COMMONWEALTH OF KENTUCKY
BEFORE THE PUBLIC SERVICE COMMISSION

ELECTRONIC APPLICATION OF)	
KENTUCKY UTILITIES COMPANY FOR)	
APPROVAL OF ITS 2020 COMPLIANCE PLAN)	CASE NO. 2020-00060
FOR RECOVERY BY ENVIRONMENTAL)	
SURCHARGE)

RESPONSE OF
KENTUCKY UTILITIES COMPANY
TO COMMISSION STAFF'S POST-HEARING REQUEST FOR INFORMATION
DATED SEPTEMBER 11, 2020

FILED: SEPTEMBER 18, 2020

Figure 1: Range of Capital Construction Costs (Source: NREL 2019 ATB)

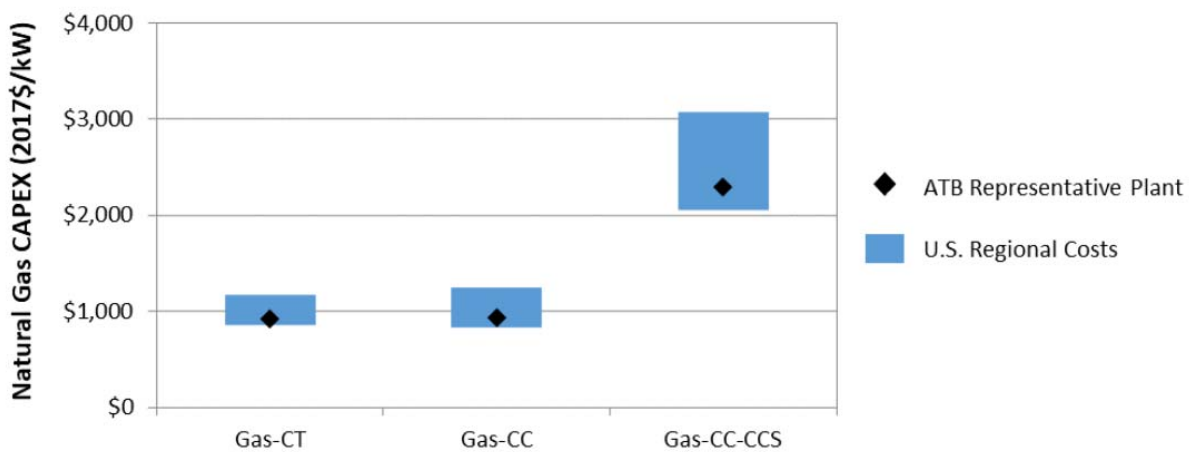
- c. Under the Replacement Generation Resources assumption, the cost for the Natural Gas Combined Cycle (NGCC) capacity should reflect the NGCC capacity cost based upon the 2019 Annual Technology Baseline from the National Renewable Energy Laboratory of \$887/kW.

The analysis that will be discussed below was updated to reflect National Renewable Energy Laboratory's 2019 Annual Technology Baseline ("NREL's 2019 ATB" or "2019 ATB") estimate

that a NGCC would cost \$887/kW (2020 in-service; 2017 dollars).⁷ Because cost of construction can vary, the chart below shows NREL's range of costs.⁸ Note that the \$887/kW is near the bottom of the range. It should also be noted that the capital cost assumption used in the Companies' analysis (\$1,044/kW in 2017 dollars for 2020 in-service) falls within the NREL range. Finally, please note NREL recently published its 2020 ATB, which shows the overnight capital cost for NGCC capacity at \$1,023/kW, which is indistinguishable from the Companies' assumption.⁹ Thus use of the NGCC construction costs at the lower range of the suggested database is now outdated.
